Pacific Cotton Ltd. (Extension)

24 October 2024

2. Observation:

Observation-01: Foundation found to be stressed. (Dormitory Building)

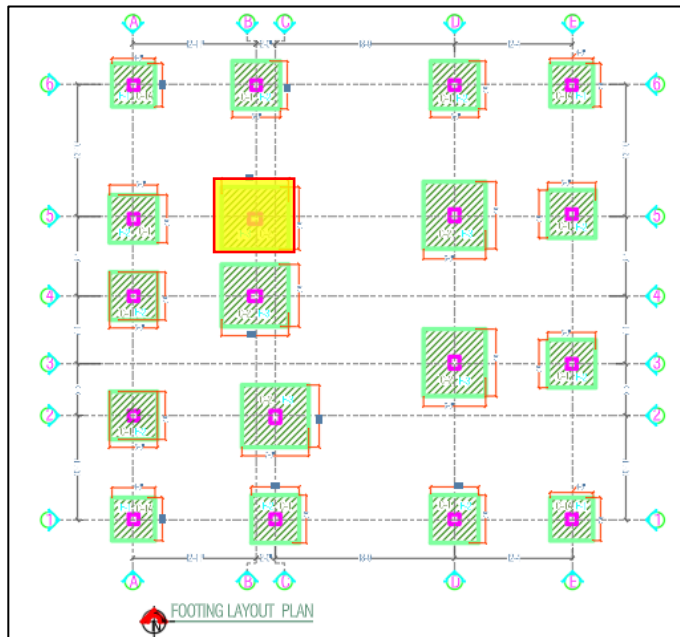
Description: Cursory calculation indicates the marked footing is stressed for bearing. The loading is considered 3 kPa for a typical floor and the bearing capacity of the soil was considered 0.72 ksf as per soil test report. The building engineer is required to review the design load and foundation stresses.

Observation-02: Poor roof drainage system. (Dormitory Building)

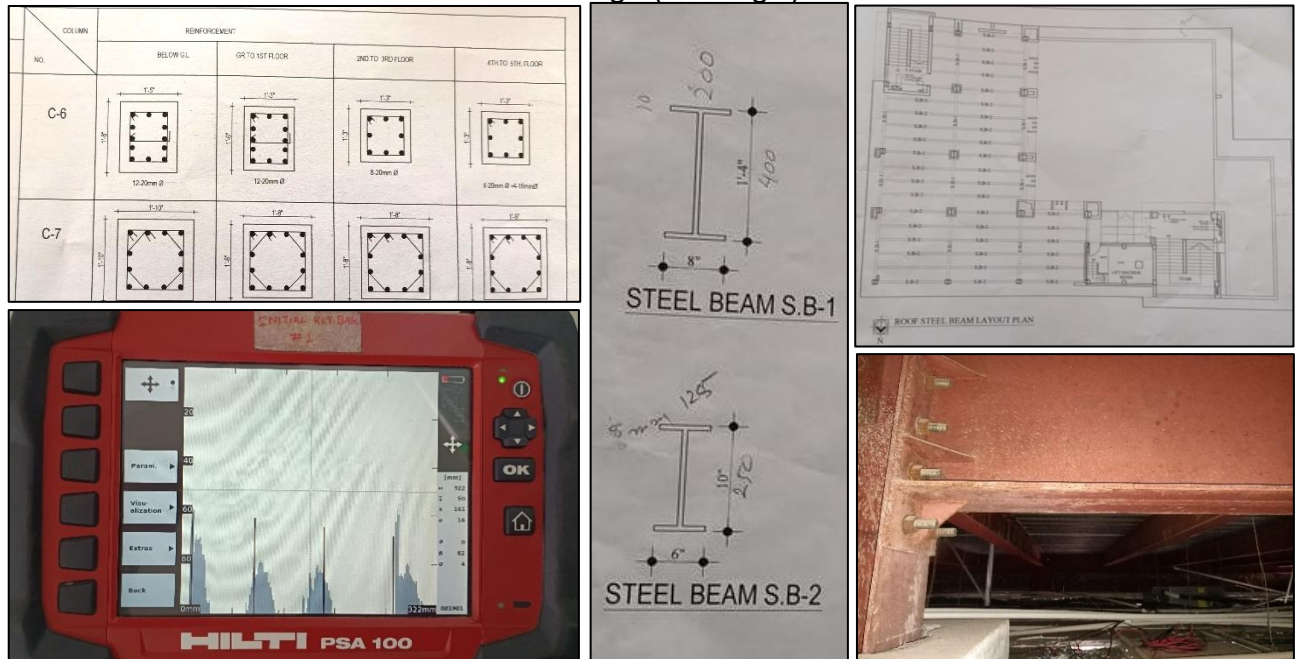
Description: During inspection, water ponding was observed on the roof. The building engineer is required to improve the roof drainage system.

Observation-08: Lack of As-built drawing. (Maintenance Office with Workshop)

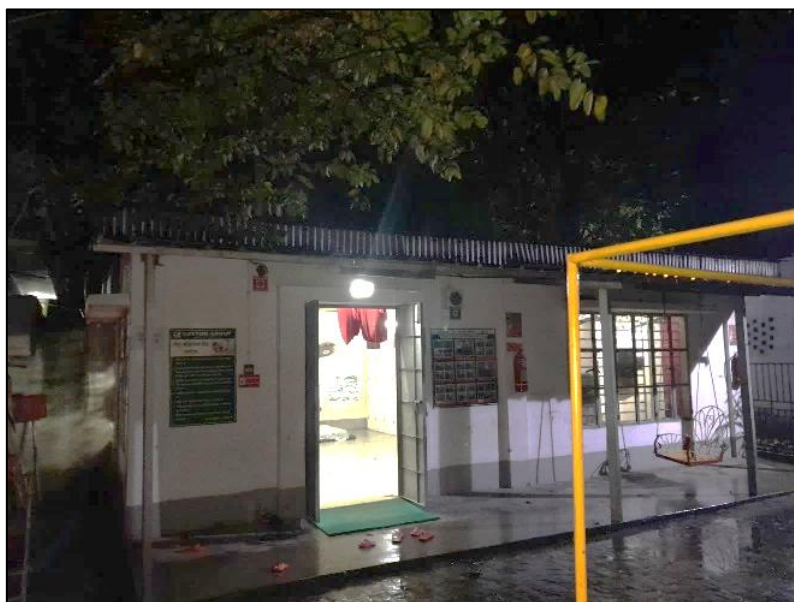
Description: The as-built drawing wasn't observed in the shed. The building engineer is required to prepare the as-built drawing.

Observation-16: Lack of As-built drawing. (WTP Shed)

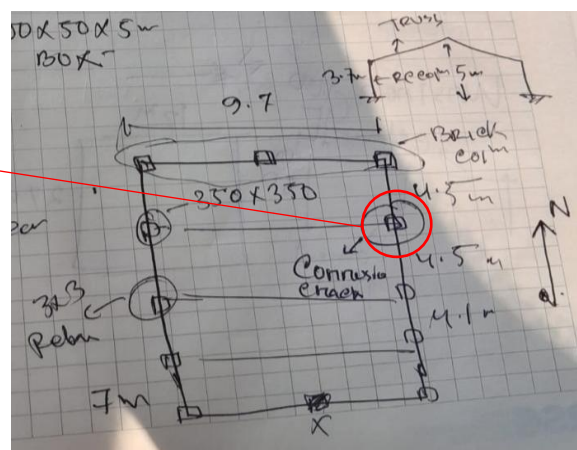
Description: The as-built drawing wasn't observed in the shed. The building engineer is required to prepare the as-built drawing.
